ADDENDUM

PROJECT: Cherokee Regional Medical Center
Emergency Department Addition
& Surgery / CS Remodel
Cherokee, Iowa

AD-2

DATE ISSUED: Wednesday, April 11, 2012

Drawing Title	
First Floor Demolition Plan - Ceiling Demo for Above Mechanical Ductwork	
From Sheet:	for CA use:
A-101	
Drawing #	
A-101.1

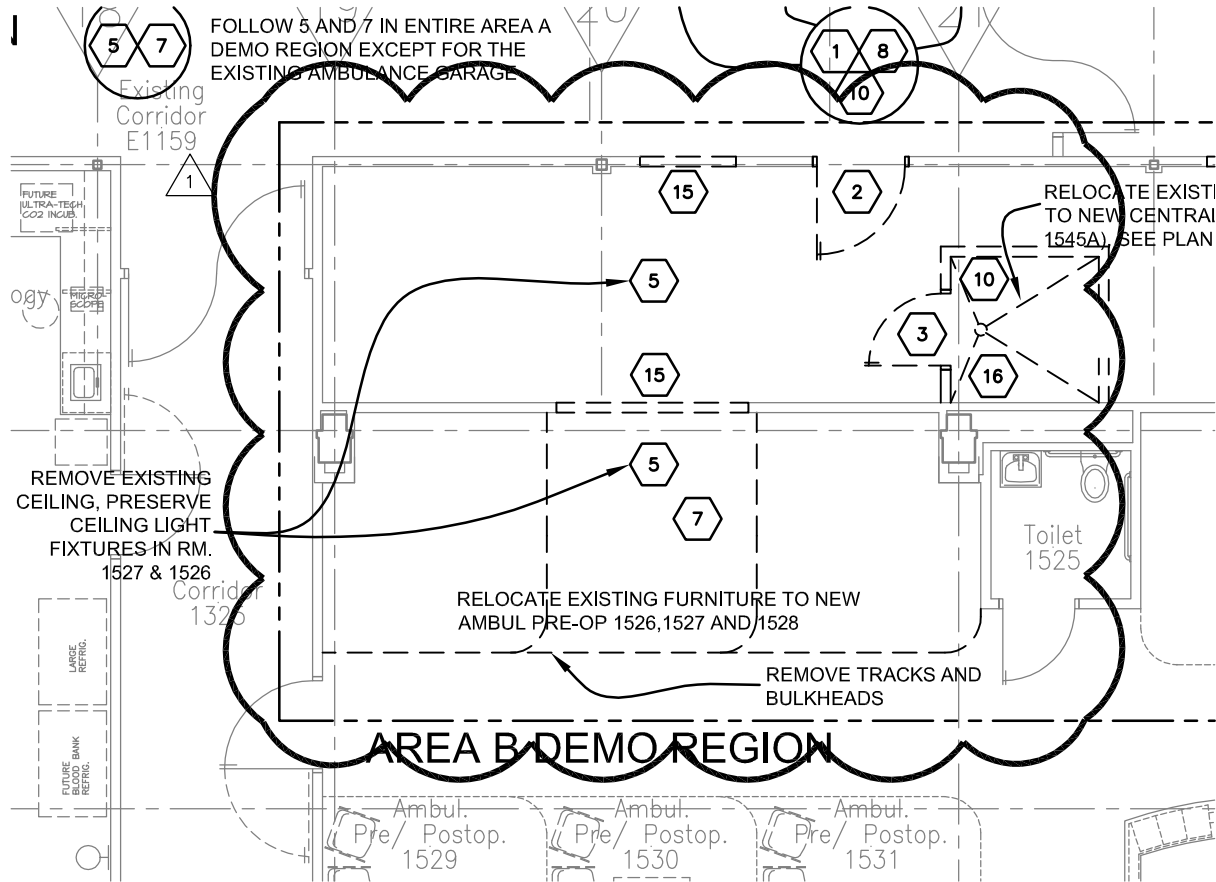
In reference to drawing Sheet A-101 - First Floor Demolition Plan, see attached Supplemental Drawing A-101.1 for an additional area of ceiling demolition.

Drawing #
 A-103.1

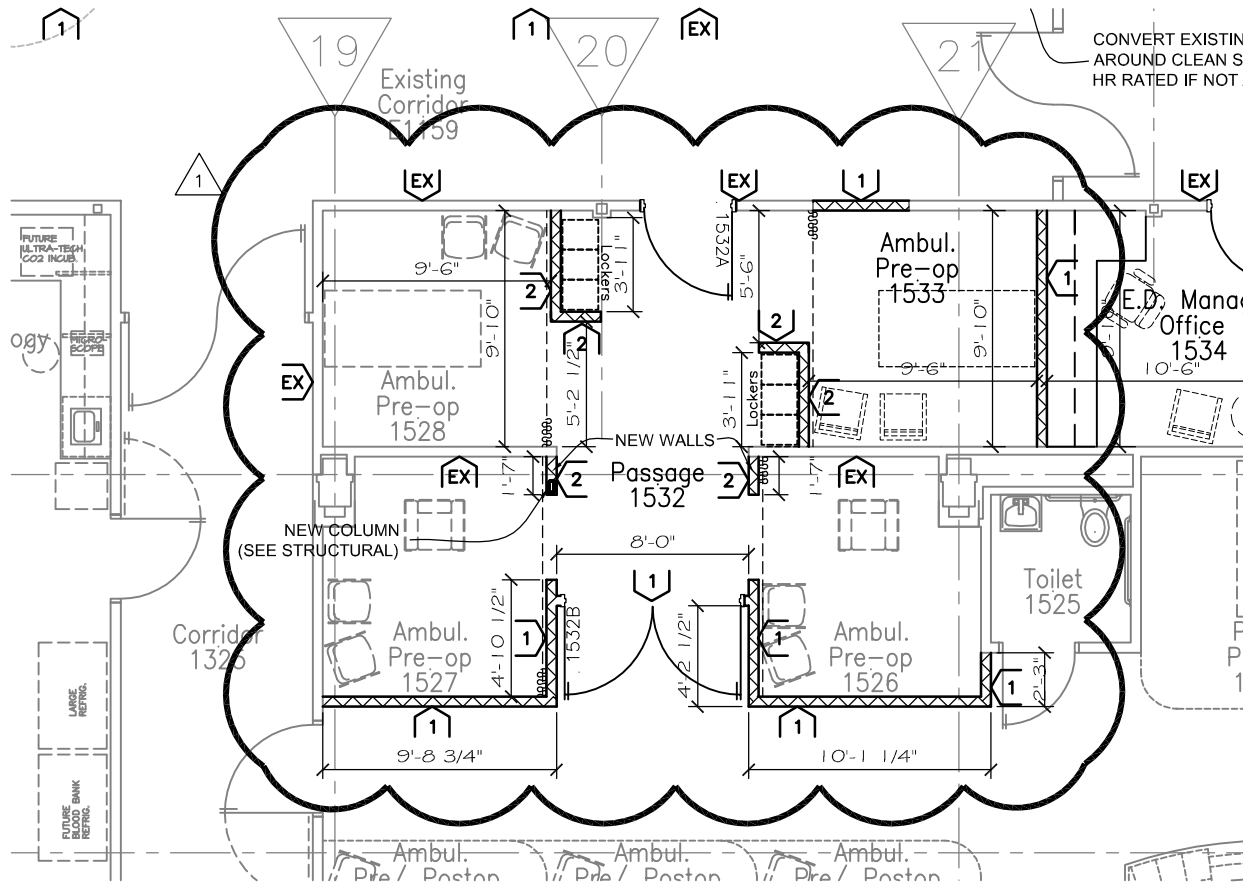
In reference to drawing Sheet A-103 – First Floor Plan Areas 'A' and 'B', see attached Supplemental Drawing A-103.1 for an updated plan incorporating a new column and surrounding walls.

Drawing # A-105.1

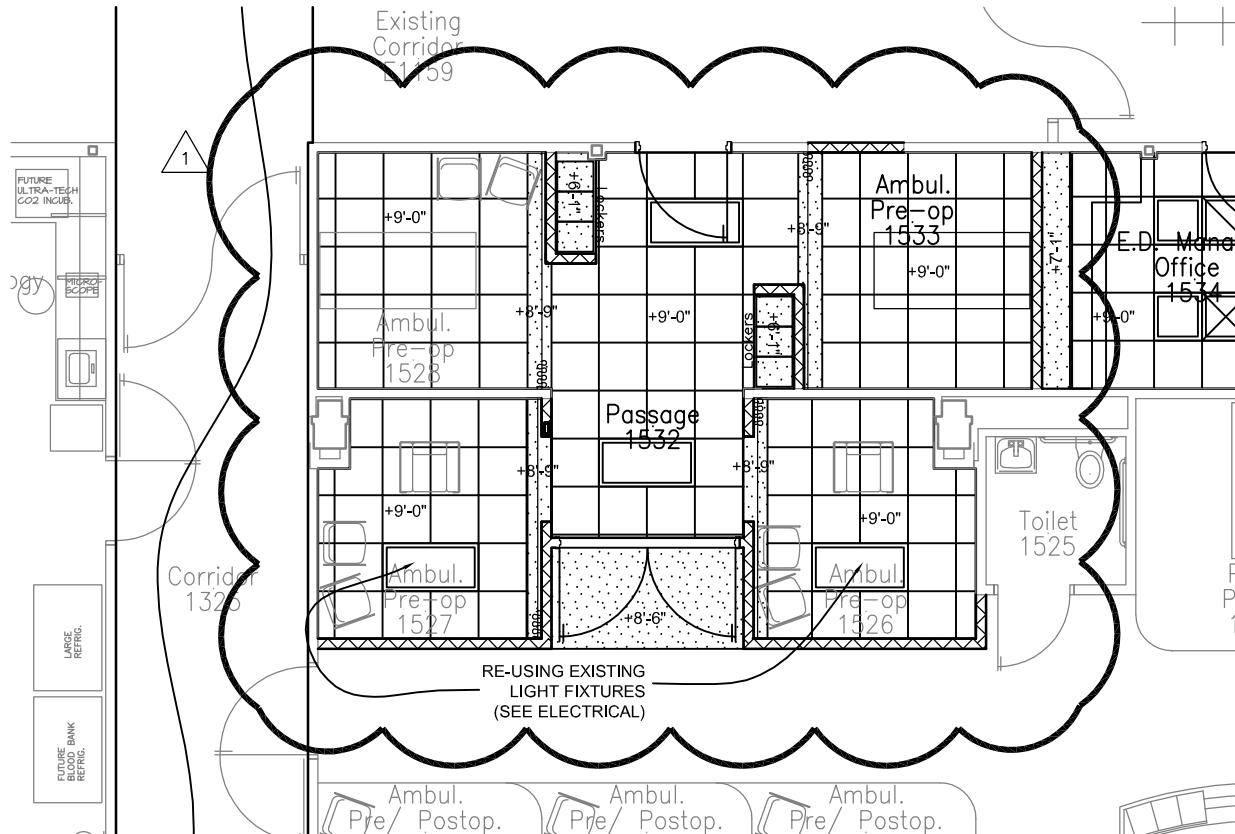
In reference to drawing Sheet A-105 – First Floor Reflected Ceiling Plan, see attached Supplemental Drawing A-105.1 for the reflected ceiling layout for the added area of ceiling removal.

Drawing #
S-001.1

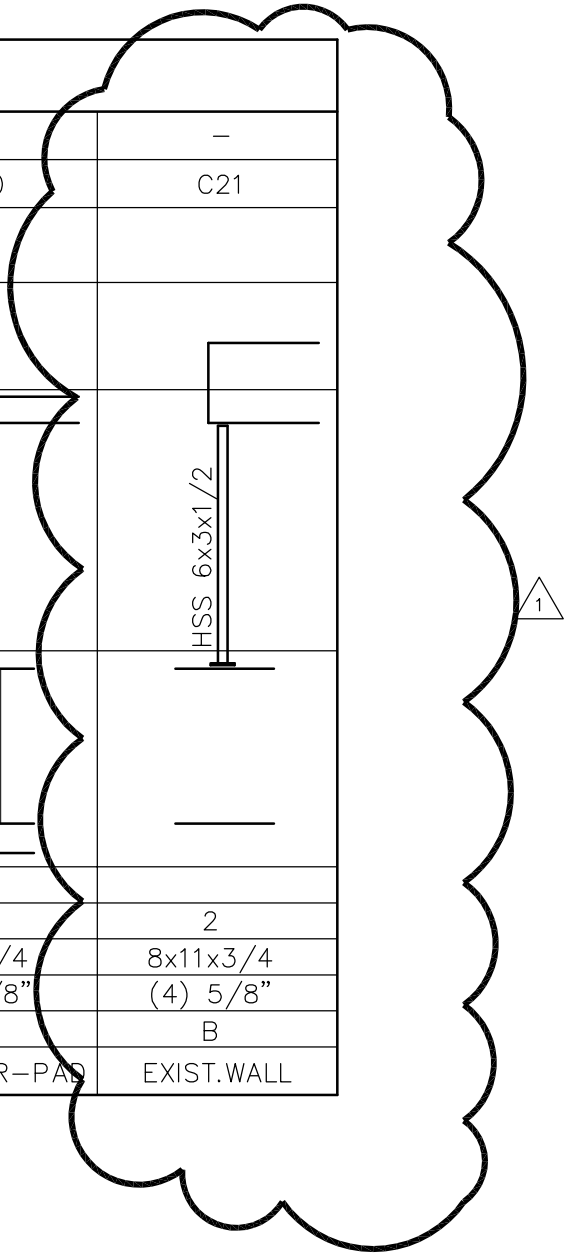
In reference to drawing Sheet S-001 – Notes & Schedules, see attached Supplemental Drawings S-001.1 for additions to the column schedule.

Drawing #
 S-101.1

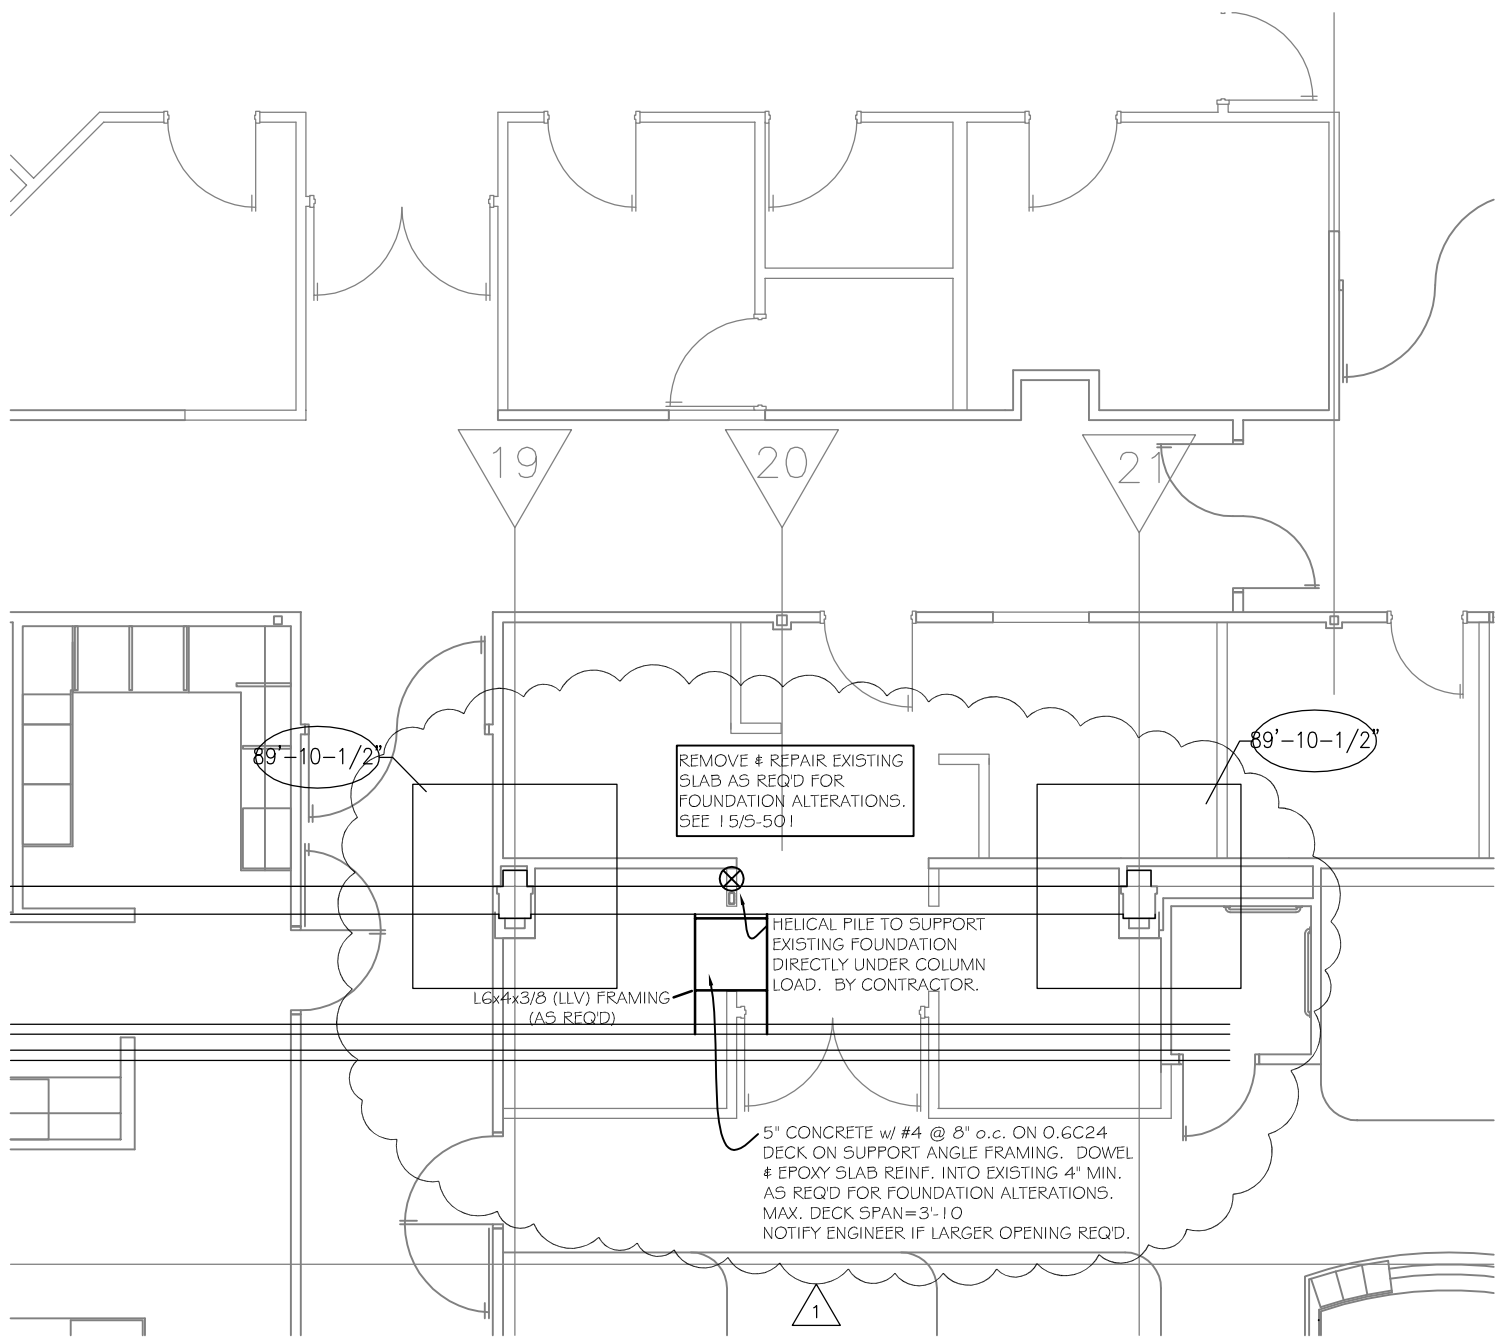
In reference to drawing Sheet S-101 – Foundation Plan Areas 'A' & 'B', see attached Supplemental Drawing S-101.1 for existing foundation alteration.

Drawing # S-102.1

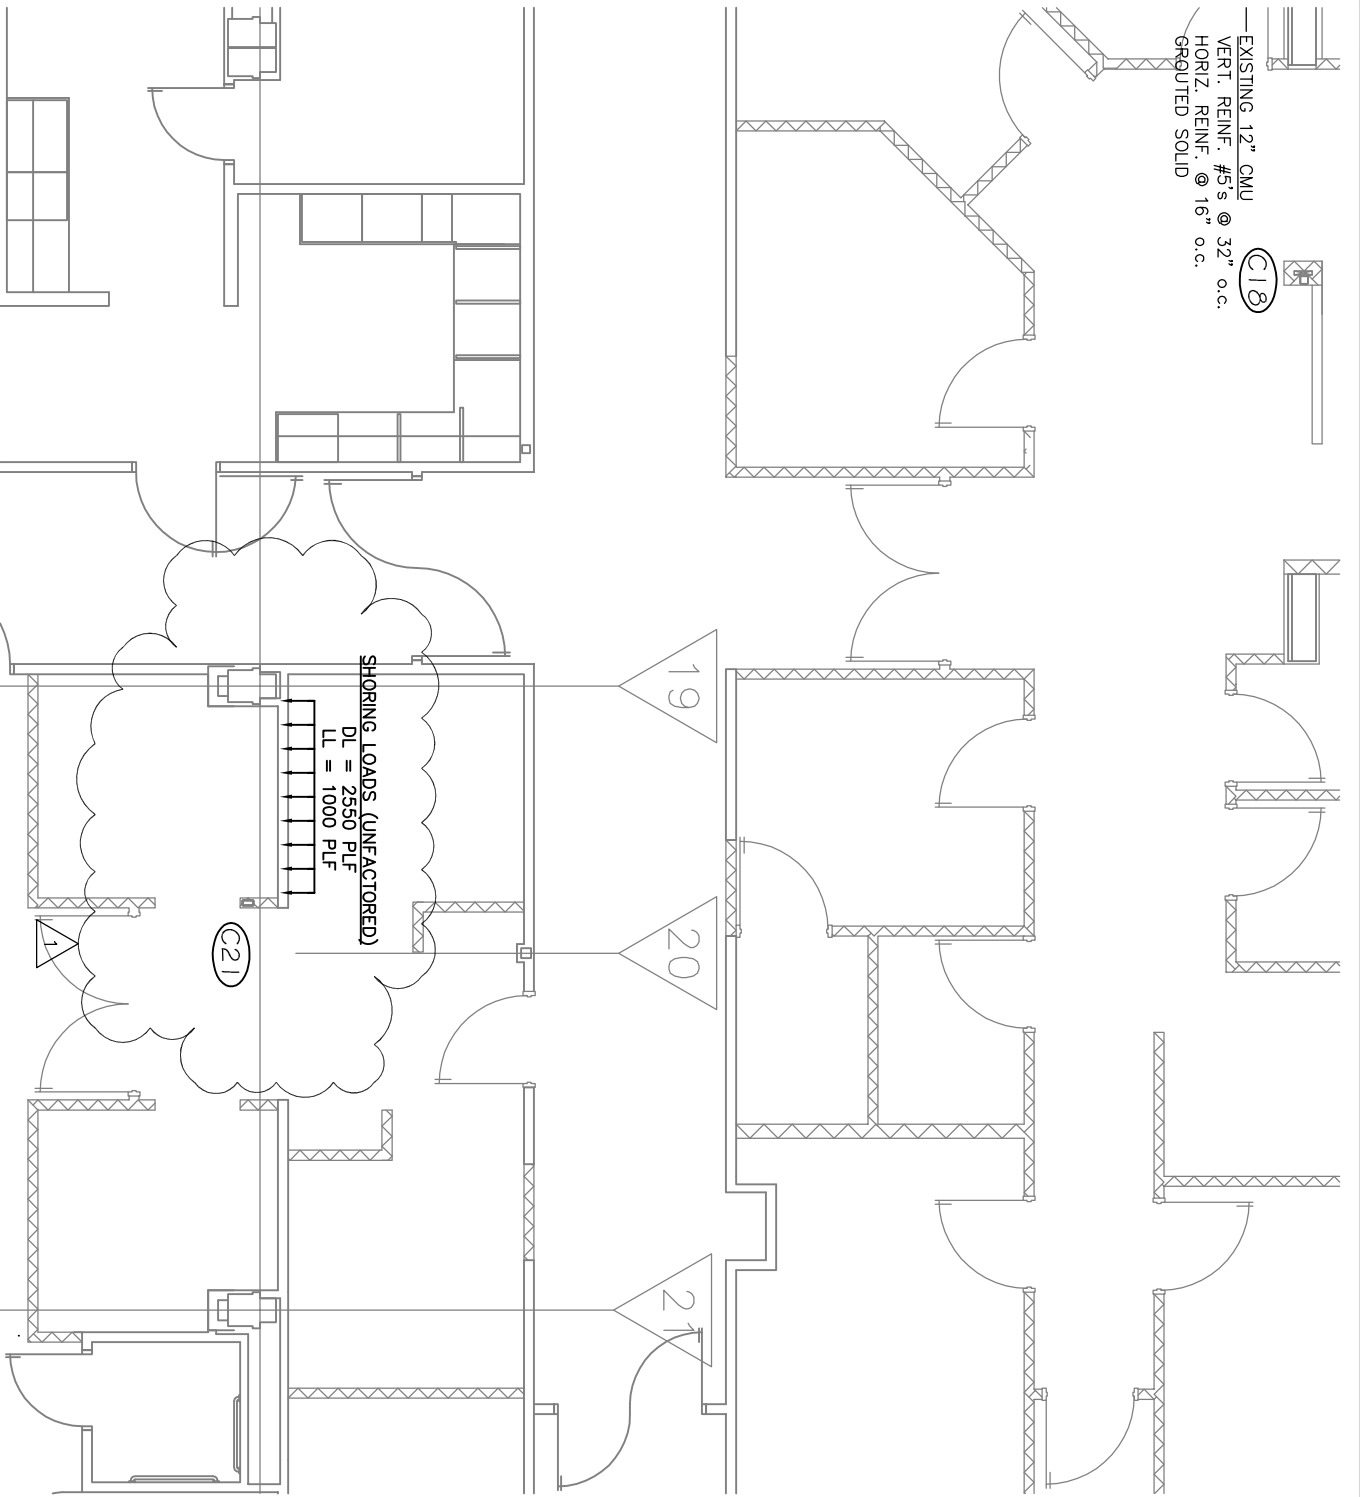
In reference to drawing Sheet S-102 – Framing Plan Areas 'A' & 'B', see attached Supplemental Drawing S-102.1 for shoring loads.

Drawing # S-103.1

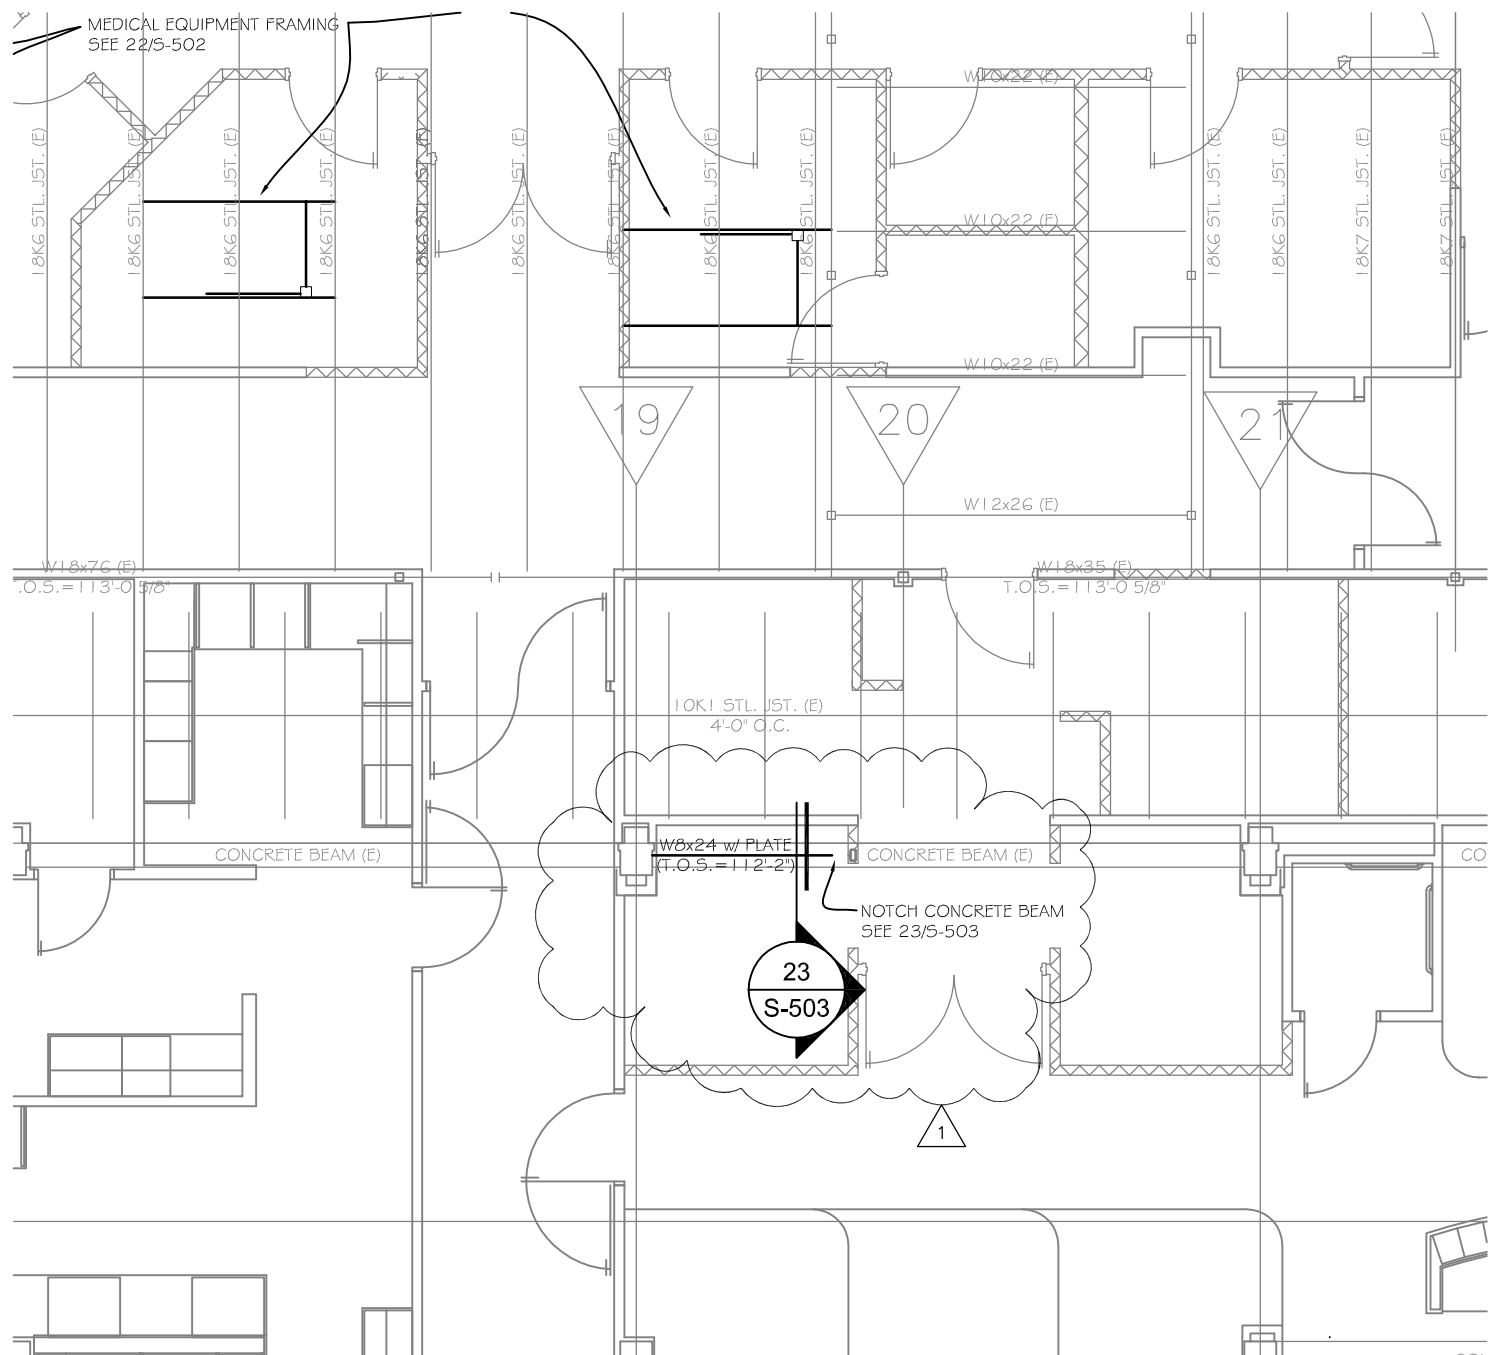
In reference to drawing Sheet S-103 – Roof Framing Plan Areas 'A' & 'B', see attached Supplemental Drawing S-103.1 for additional framing.

Drawing #
M-100.1

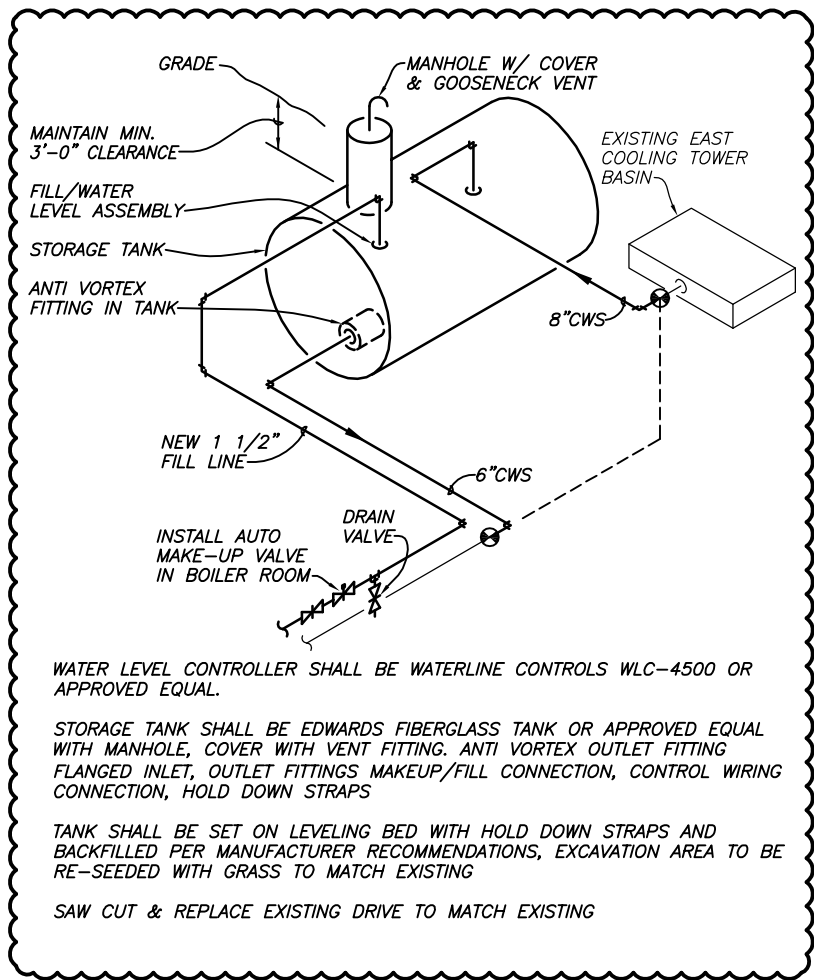
Remote cooling tower sump:

Provide new makeup/fill valve in existing Boiler Room and new water level controller in the remote sump.

In reference to drawing Sheet M-100 - Basement Mechanical Demolition and New Work Plans, see attached Supplemental Drawings M-100.1 and M-100.2.

WATER LEVEL CONTROLLER SHALL BE WATERLINE CONTROLS WLC-4500 OR APPROVED EQUAL.

STORAGE TANK SHALL BE EDWARDS FIBERGLASS TANK OR APPROVED EQUAL WITH MANHOLE, COVER WITH VENT FITTING. ANTI VORTEX OUTLET FITTING FLANGED INLET, OUTLET FITTINGS MAKEUP/FILL CONNECTION, CONTROL WIRING CONNECTION, HOLD DOWN STRAPS

TANK SHALL BE SET ON LEVELING BED WITH HOLD DOWN STRAPS AND BACKFILLED PER MANUFACTURER RECOMMENDATIONS, EXCAVATION AREA TO BE RE-SEEDED WITH GRASS TO MATCH EXISTING
